Project	IEEE 802.16 Broadband Wireless Access Working Group < http://ieee802.org/16 >	
Title	Fixes for Lost of MOB_HO-IND (Cancel) Messages	
Date Submitted	2008-03-10	
Source(s)	Chi-Chen Lee, I-Kang Fu MediaTek Inc. No. 1, Dusing Rd. 1 Science-Based Industrial Park, Hsinchu, Taiwan 300	chichen.lee@mediatek.com IK.Fu@mediatek.com
Re:	IEEE 802.16 Letter Ballot Recirculation #26b, on P802.16Rev2/D3, as announced in IEEE 802.16-08/006.	
Abstract	In IEEE 802.16 Rev2/D3, there is no definition on MS's/BS's behavior when the message MOB_HO-IND message with the HO Cancel commend is lost. This contribution explains the potential problems and proposes a resolution to resolve this confusion.	
Purpose	Accept the proposed text modification to IEEE 802.16 Rev2	
Notice	<i>This document does not represent the agreed views of the IEEE 802.16 Working Group or any of its subgroups. It represents only the views of the participants listed in the "Source(s)" field above. It is offered as a basis for discussion. It is not binding on the contributor(s), who reserve(s) the right to add, amend or withdraw material contained herein.</i>

Fixes for Lost of MOB_HO-IND (Cancel) Messages

Chi-Chen Lee, I-Kang Fu

Figure 7 –MOB_HO-IND (cancel) message is received but when MS context was deleted at serving BS

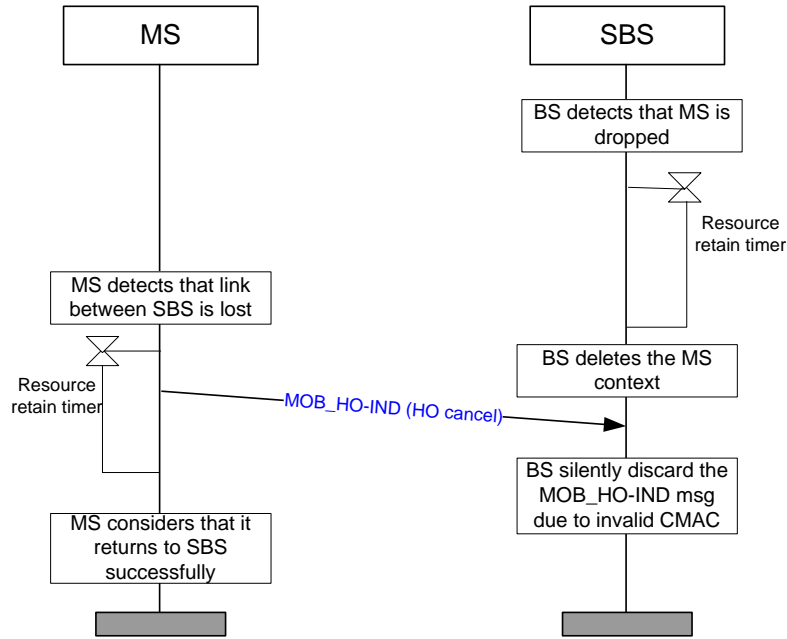
Figure 7 points out the issue that drop detection at BS and MS may be different and even the MOB_HO-IND message is received correctly at serving BS it still may be discard due to the MS context no longer exists. In this case, the MS has no idea that SBS has deleted its context and may continue requesting bandwidth.

Figure 8 – Lost of MOB_HO-IND (cancel) message when MS detects drop

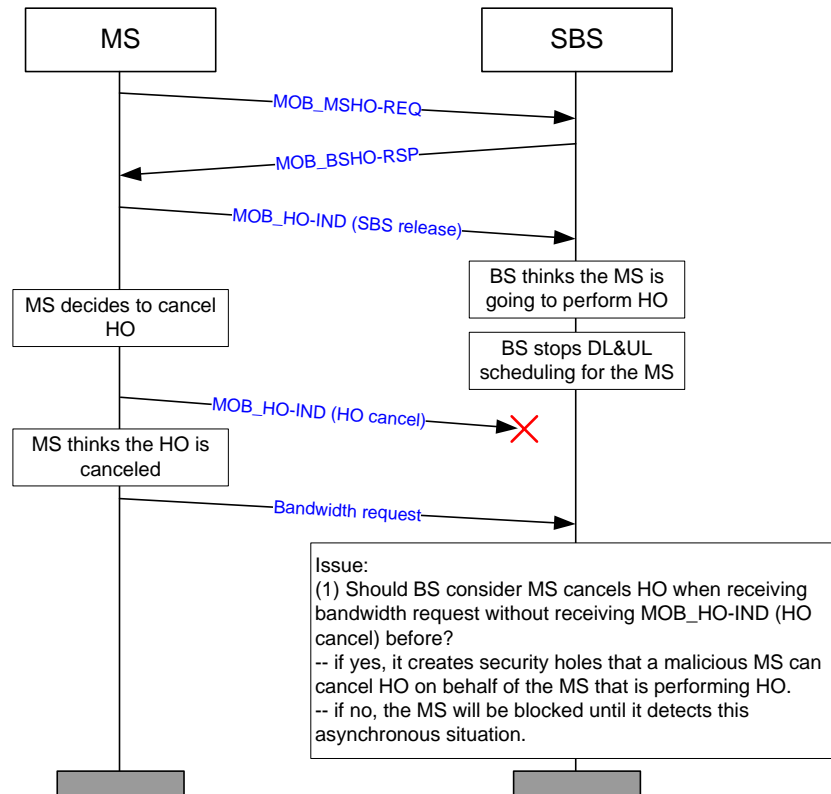
Figure 8 shows the potential security issue if the MOB_HO-IND (cancel) message is lost. If the serving BS that received MOB_HO-IND (release) message from the MS before but accept bandwidth request from the MS that should perform handover, it creates a security hole that a malicious MS can cancel HO operation on behave of any MS. However, if the serving BS ignores the bandwidth request, the MS will be blocked until it detects the asynchronous situation.

Figure 9 – [Remedy 1] Detection of lost of MOB_HO-IND (cancel) message

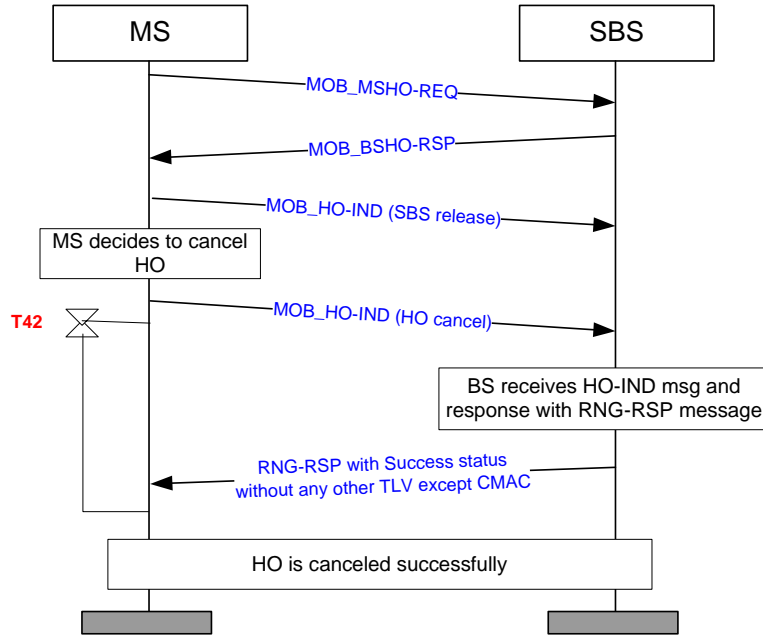
The suggested remedy one is illustrated in Figure 8. An MS shall start T42 after sending MOB_HO-IND (cancel) message and wait for RNG-RSP message with Success status without any other TLV encoding, e.g. PHY adjustment, except CMAC as the acknowledgement of reception of MOB_HO-IND message from serving BS. The BS receives MOB_HO-IND (cancel) message with valid CMAC should send RNG-RSP message with Success status without any other TLV encoding except CMAC to the MS. If the MS does not receive the RNG-RSP message before the expiration of T42, it should consider the MOB_HO-IND (cancel) message is lost.

MS shall start T42 immediately after sending the MOB_HO-IND message (HO_IND_type = 0b01). If T42 is expired and MS does not receive RNG-RSP message with Success status without any other TLV encoding except CMAC, it shall consider the MOB_HO-IND message is lost and reacts as if it detects drop during HO (6.3.22.2.6). In this case, if MS decides to return to serving BS, it should perform network reentry with serving BS as described in section 6.3.22.2.6. The BS shall send RNG-RSP message with Success status without any other TLV encoding except CMAC when it receives a MOB_HO-IND message with valid CMAC.

Figure 10 –[Remedy 2] Network reentry after lost of MOB_HO-IND (cancel) message

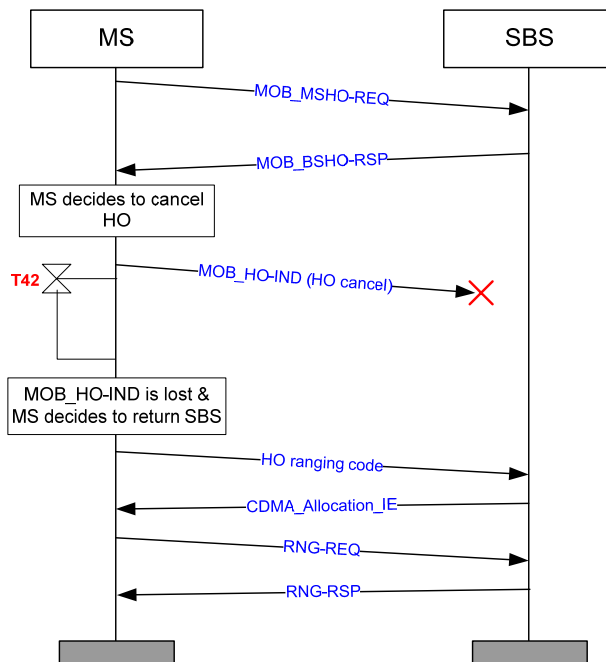
The suggested remedy two as described in Figure 10 is once the MS detects that MOB_HO-IND (cancel) message is lost, it should behave as it detects drop and take action that described in section 6.3.22.2.6 *Drops during HO*. If the MS decides to return serving BS and the resource retain timer is not expired, it should perform network reentry with serving BS.

When the MS has detected a drop during network reentry with a target BS, it may attempt network reentry with its preferred target BS as through Cell Reselection (see 6.3.22.2.1), ~~and~~ may include resuming communication with the serving BS by sending MOB_HO-IND message with HO_IND_type = 0b01 (HO cancel), and may perform network reentry with serving BS if it detects (see 6.3.22.2.3) that MOB_HO-IND message with HO_IND_type = 0b01 is lost.

MS shall perform CDMA ranging with target BS or serving BS if MOB_HO-IND message (HO_IND_type = 0b01) is lost using codes from HO codes domain.

If MS attempts network reentry with the serving BS, the MS shall transmit RNG-REQ with all required TLVs as if performing HO to the serving BS. The serving BS may now identify that HO attempt by MS was dropped before by learning that Serving BS ID in RNG-RSP message is identical to its BS ID. The serving BS shall now send RNG-RSP message with HO process optimization TLV and network reentry may continue as in typical nondrop case.
